APPLICATION NO.	FILING DATE	FIRST NAMED INVENTOR	ATTORNEY DOCKET NO.	CONFIRMATION NO.
10/663,918	09/16/2003	Richard A. Wilsak	37,512	2288
7590	12/23/2008		EXAMINER	
BP America Inc. Docket Clerk, BP Legal, M.C. 5East 4101 Winfield Road Warrenville, IL 60555			POPOVICS, ROBERT J	
			ART UNIT	PAPER NUMBER
			1797	
			MAIL DATE	DELIVERY MODE
			12/23/2008	PAPER

Office Action Summary	Application No.	Applicant(s)	
	10/663,918	WILSAK ET AL.	
	Examiner	Art Unit	
	/Robert James Popovics/	1797

DETAILED ACTION

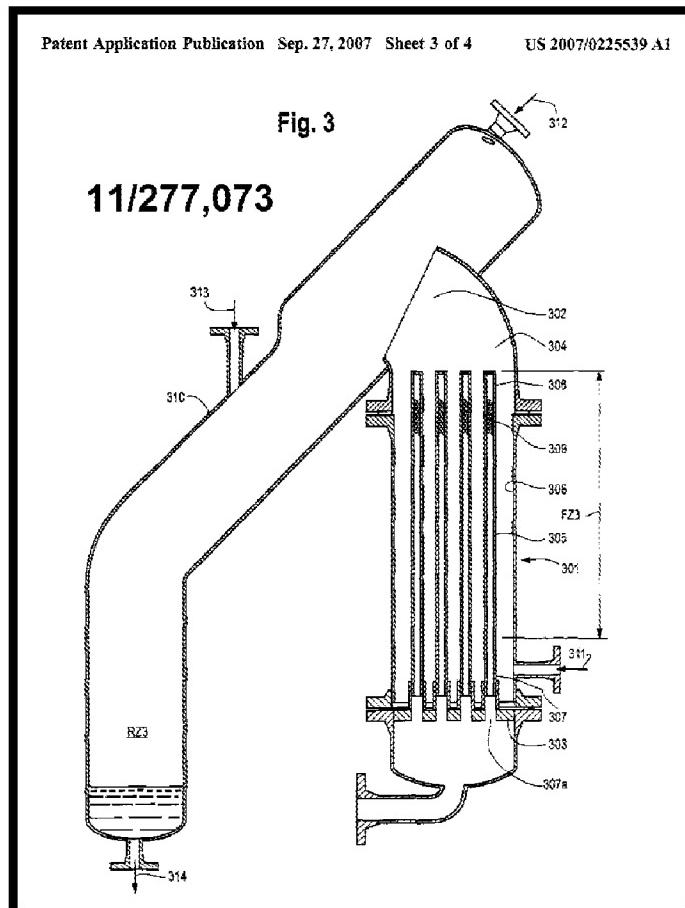
Claims **1,2,5-16,40,41,44,45,48 and 49** are rejected under 35 U.S.C. 112, first paragraph, as failing to comply with the **enablement** requirement. The claim(s) contains subject matter which was not described in the specification in such a way as to enable one skilled in the art to which it pertains, or with which it is most nearly connected, to make and/or use the invention. Applicant has failed to teach those skilled in the art how a displacement fluid entering through nozzle 29 would be caused to flow in a manner that would displace at least a portion of liquid from a slurry feed, i.e.:

wherein the displacement fluid is insoluble in the slurry feed components and displaces at least a portion of the liquid from the slurry feed past the filter and into the lower concentration zone to produce a filtrate in the lower concentration zone.

In this regard, it is noted that the only apparatus disclosed to accomplish this step is Fig. 1, which discloses an open chute 33. As such, it is unclear how the above stated step would be accomplished. It is axiomatic that a fluid under pressure will follow the path of least resistance. Referring to Fig. 1, that would be chute 33.

Comparing Figure 3 of **US 2007/0225539 A1** with Fig. 1 of the instant disclosure

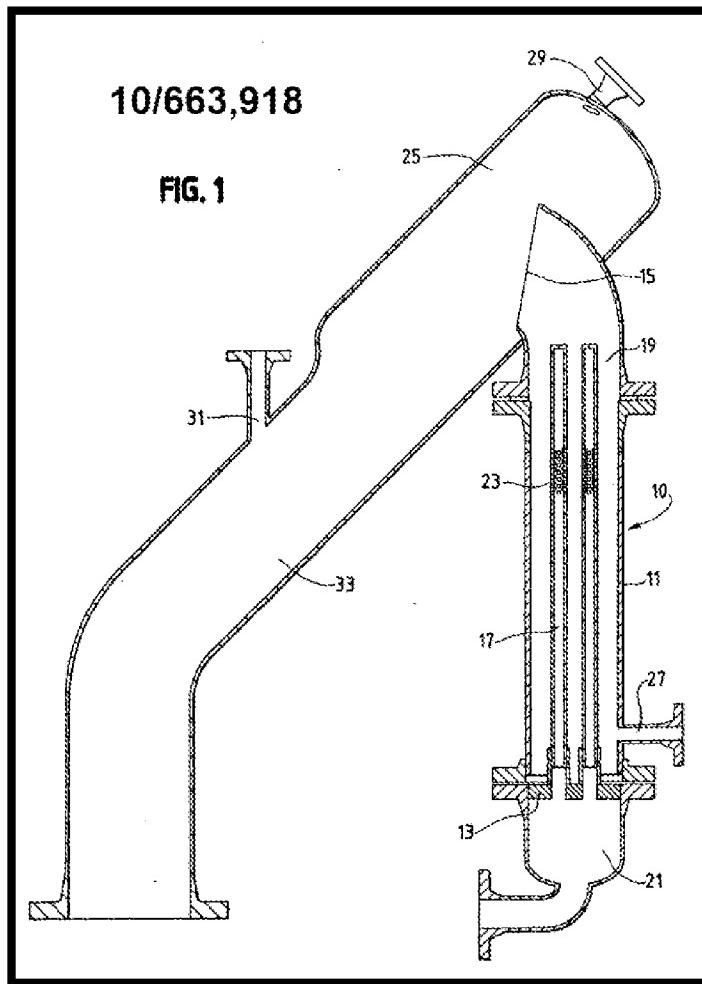
Claims 1,2,5-16,40,41,44,45,48 and 49 are rejected under 35 U.S.C. 112, first paragraph, because the **best mode** contemplated by the inventor has not been disclosed. Evidence of concealment of the best mode is based upon **Figure 3 of US 2007/0225539 A1**.

it would appear that something is missing.
